Addendum No. 2

Date:	May 30, 2013
To:	Contractors
From:	Rick James - Project Manager
Reference:	George S. Eccles Student Life Center University of Utah – Salt Lake City, Utah DFCM Project No. 08015750
Subject:	**Addendum No. 2**

2.2 **GENERAL ITEMS**: See attached Architect's Addendum No. 1 dated May 28, 2013.

A2 SB110 FOOTING & FOUNDATION PLAN - WEST ALT #1

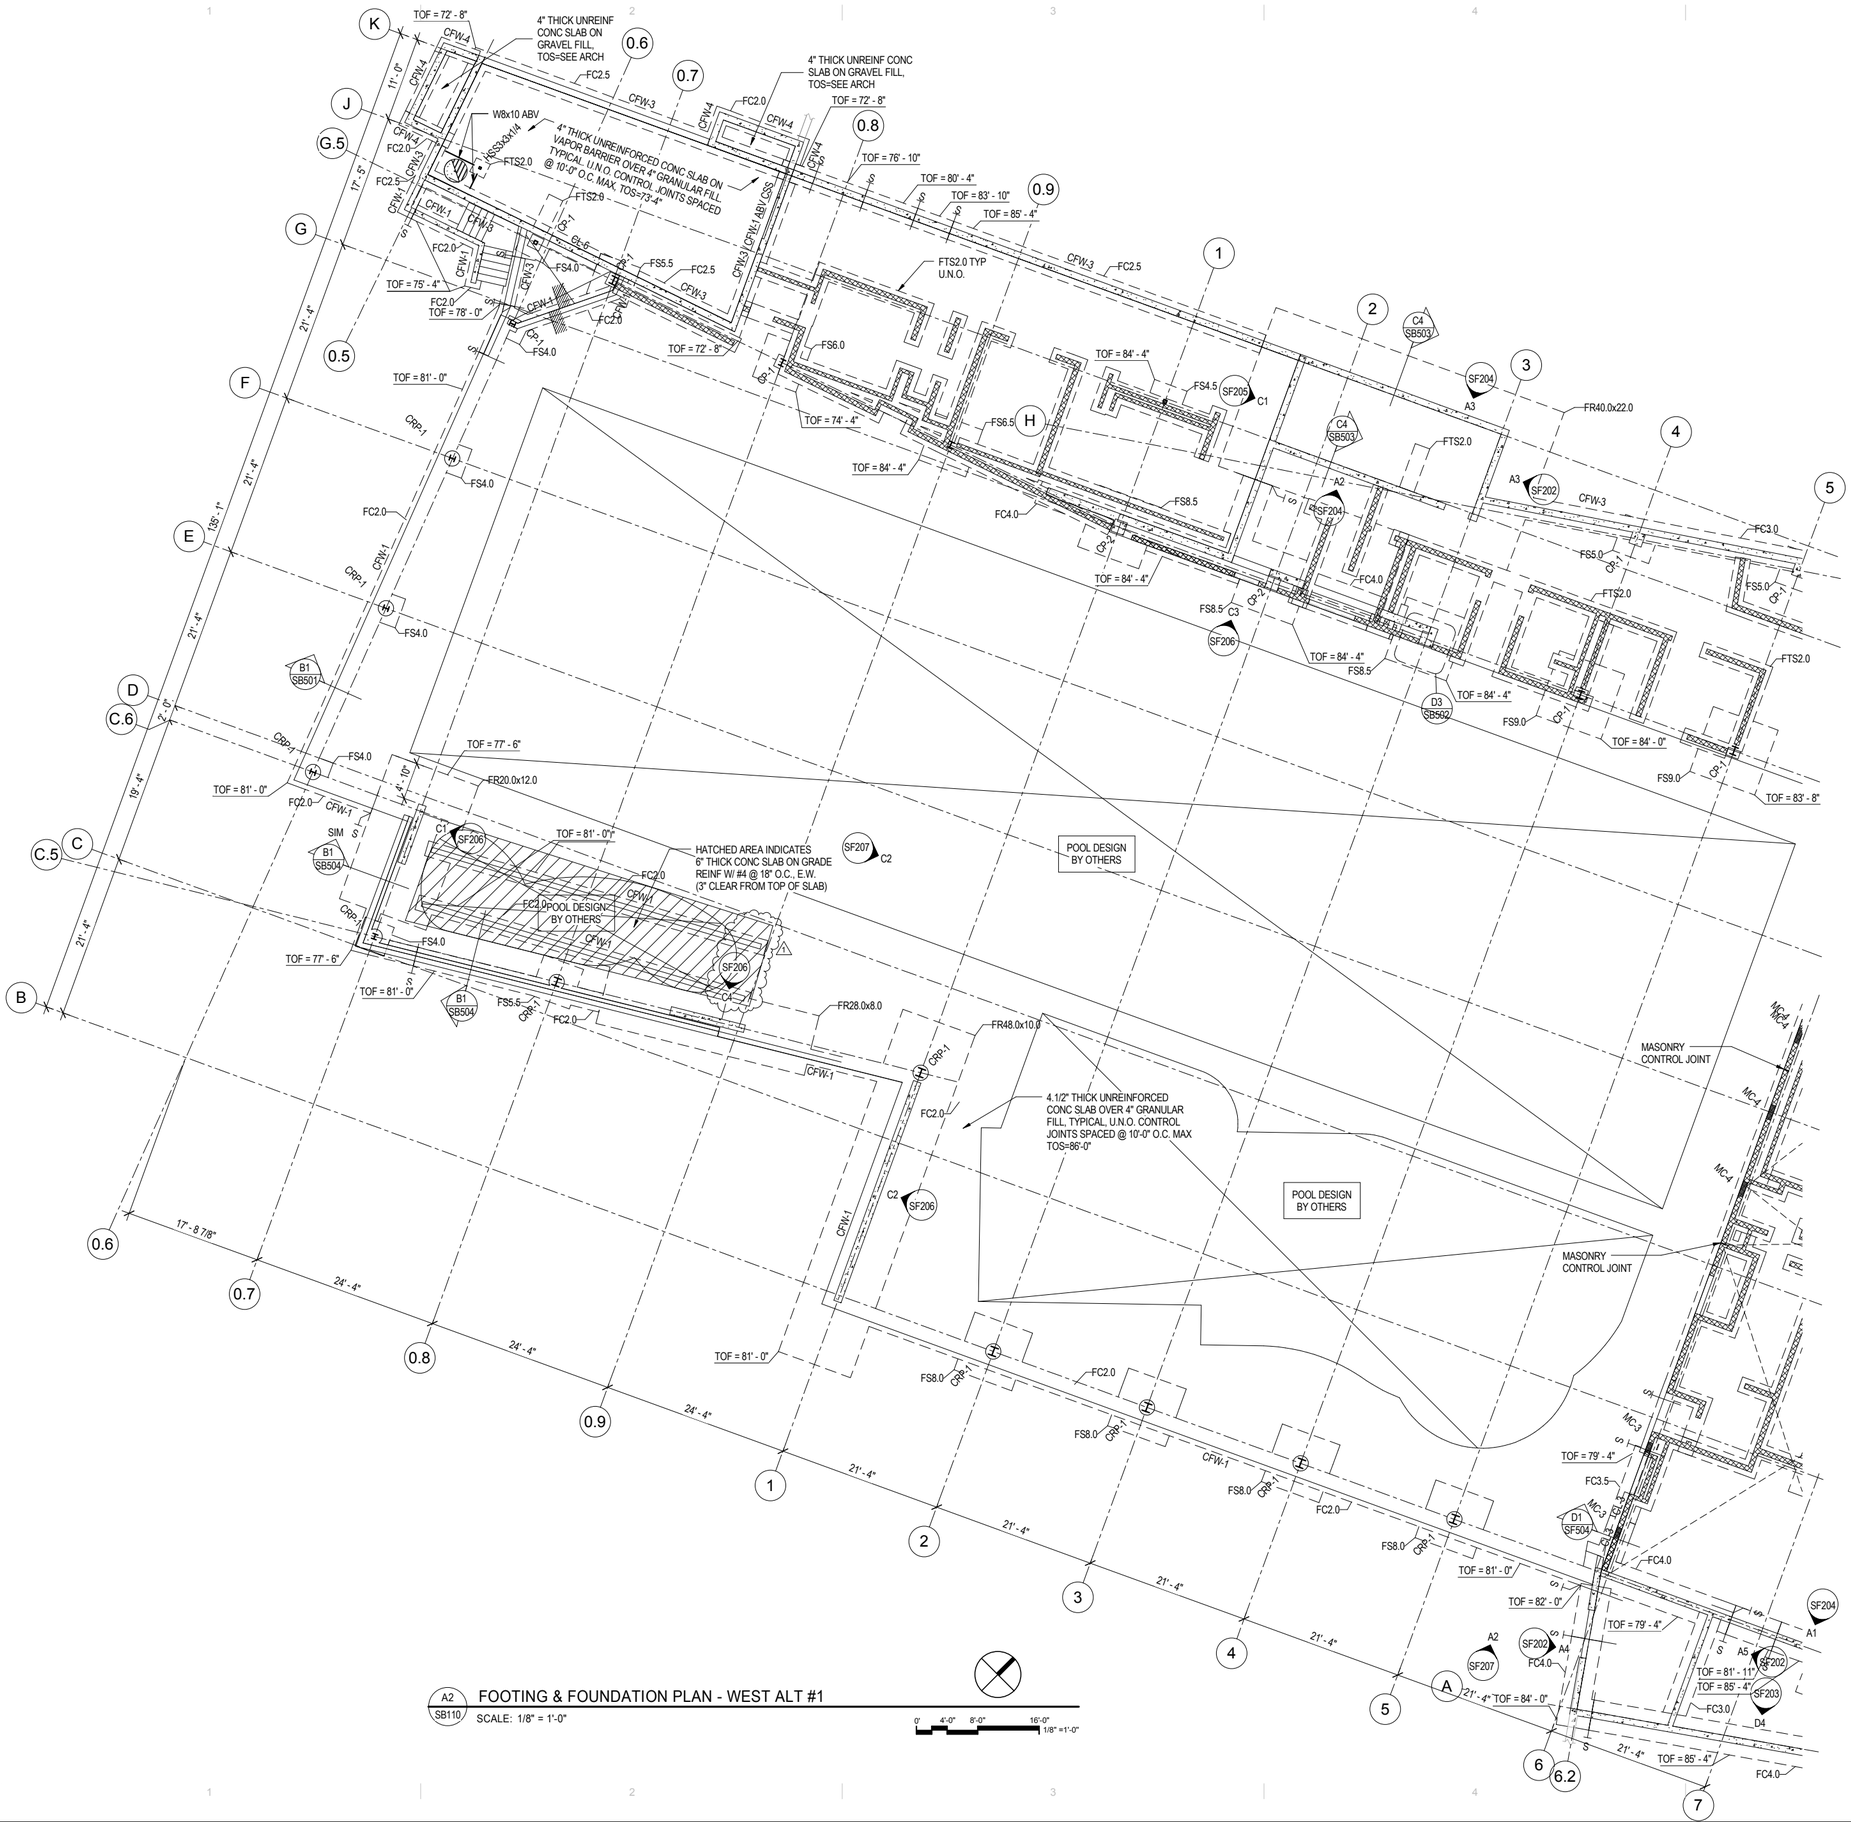
A1.11 Sheet SB110: Replace SB110 with new SB110
1. Extend spa foundation near grid 0.9

A2 / SB504 TYPICAL LANDSCAPE CONCRETE RETAINING WALL SCHEDULE AND DETAIL

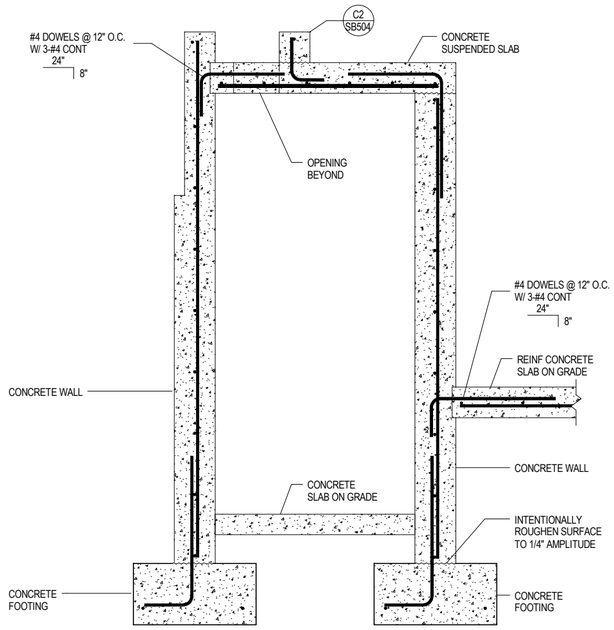
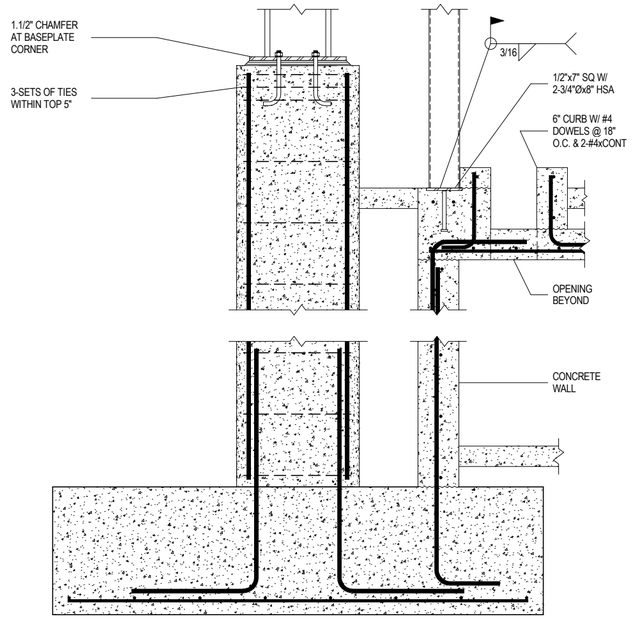
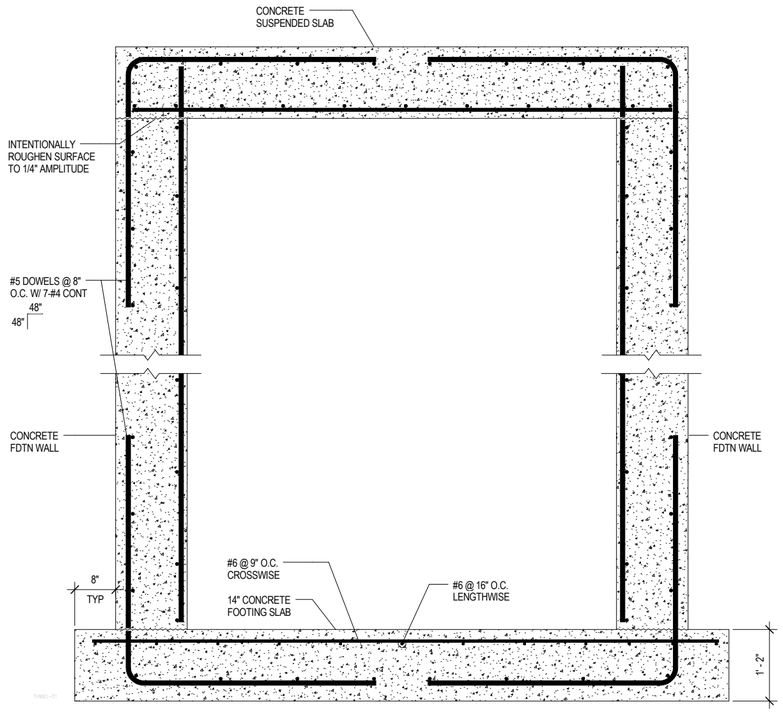
A1.12 Sheet SB 504: Replace sheet SB504 with new SB504
1. Revise detail B1
2. Add details A2 landscape retaining wall schedule. See attached Sheet SB504

CEILING BRACING DETAILS

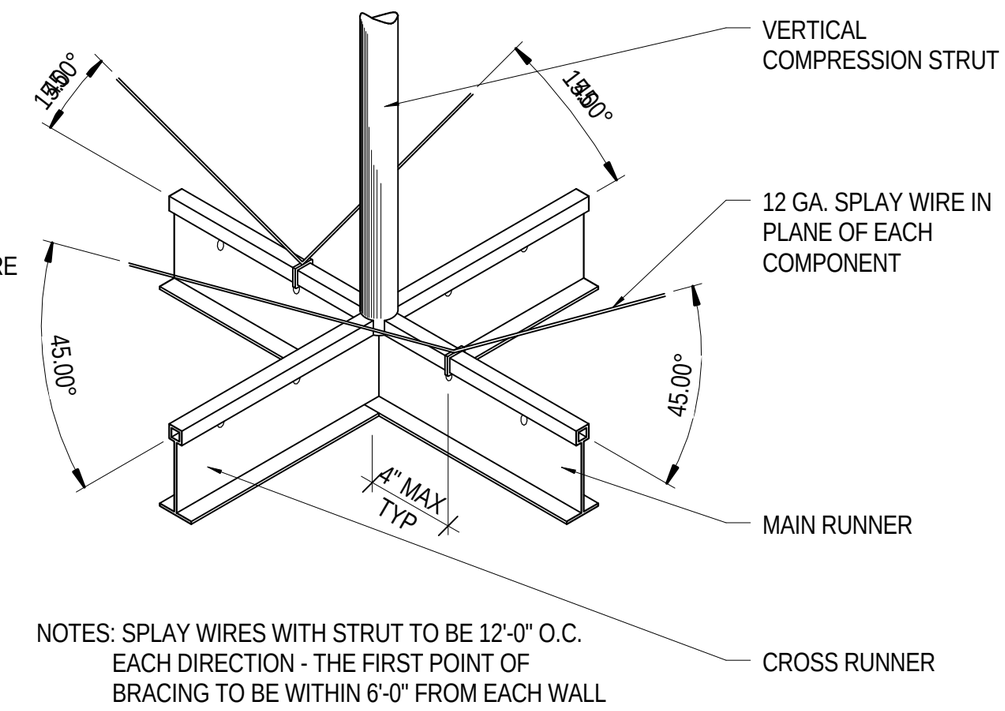
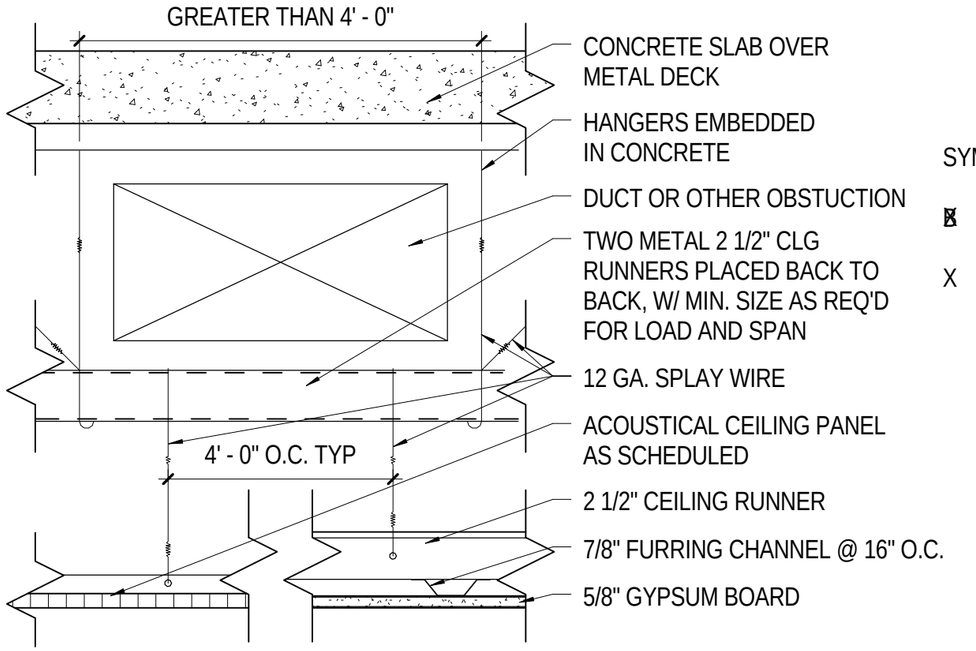
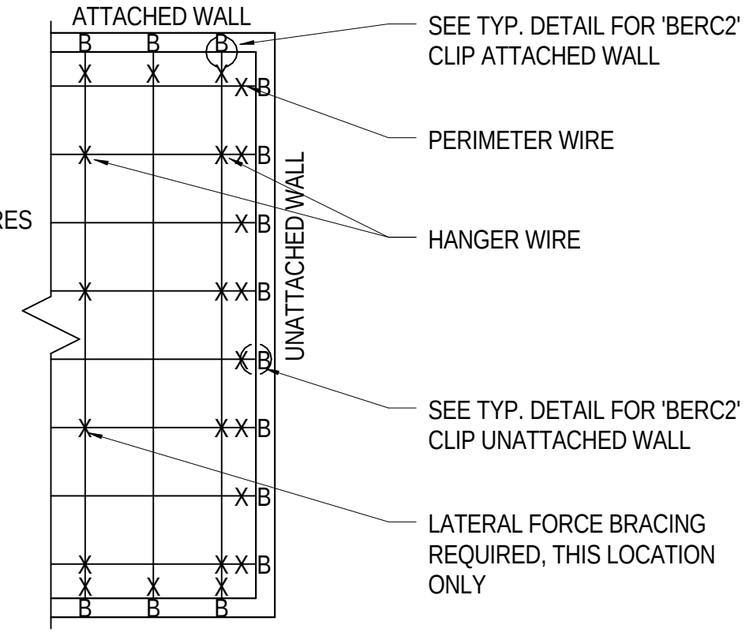
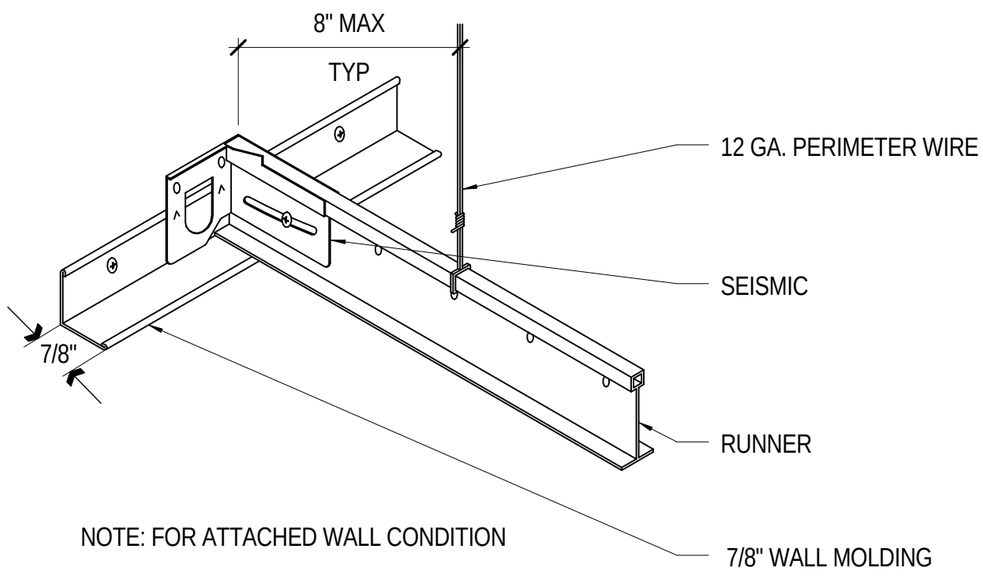
1. Revised ceiling bracing details. C4/AE540. See attached AD01-AE006

1 ED100.1 DEMOLITION ELECTRICAL SITE PLAN

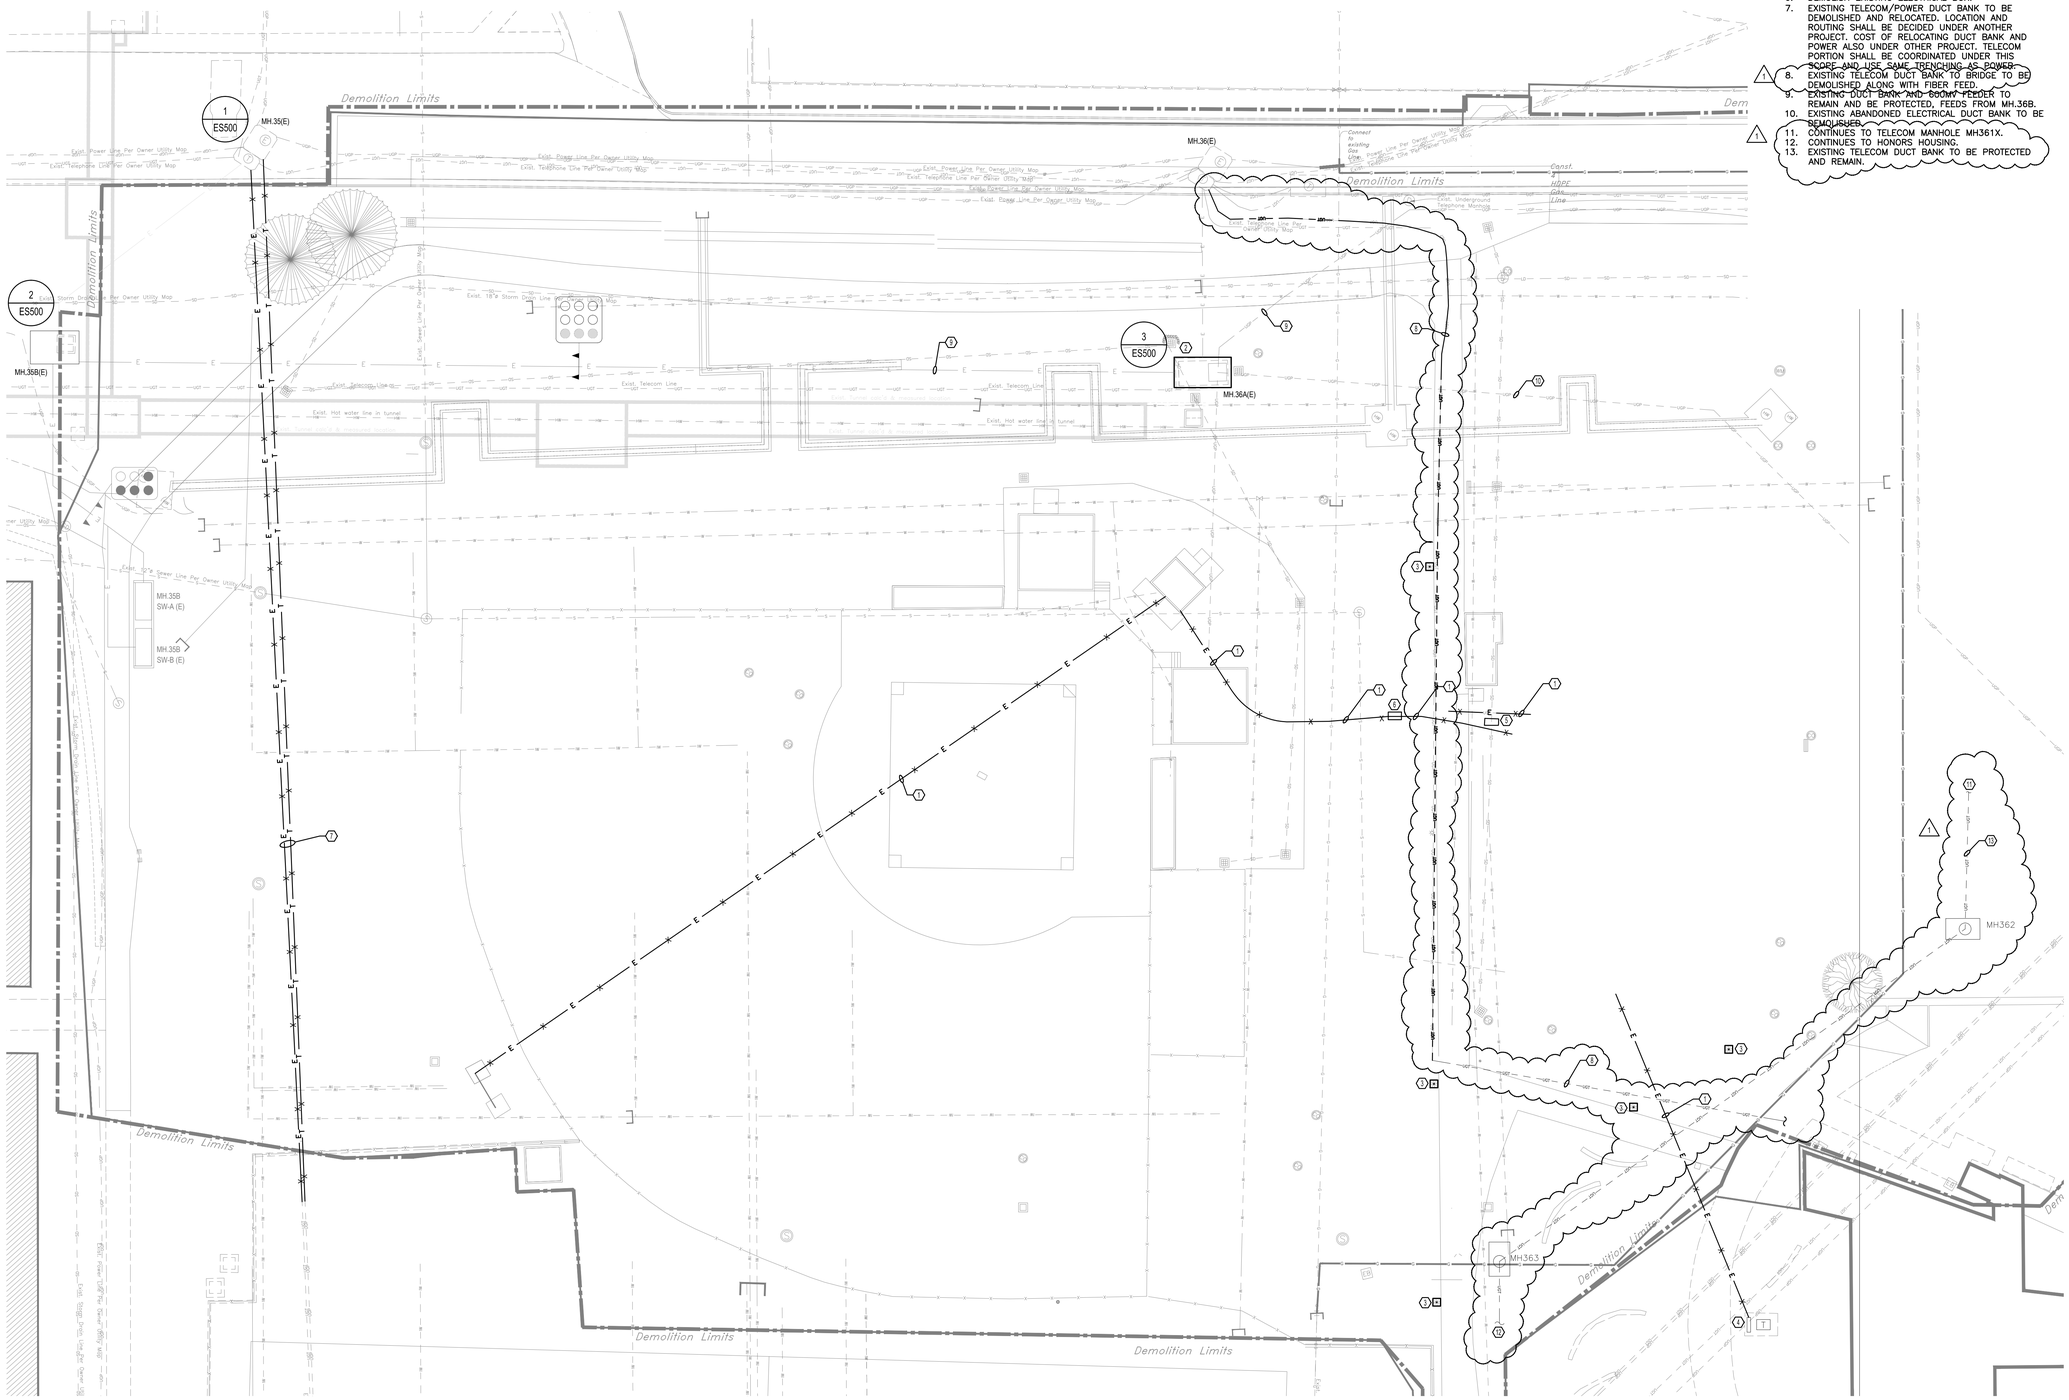
1. Change: Keyed Note #8
2. Add: Keyed Note #11 – See attached sheet ED100.1
3. Add: Keyed Note #12 – See attached sheet ED100.1
4. Add: Keyed Note #13 – See attached sheet ED100.1
5. Add: Showed locations of telecom manholes and existing routing.
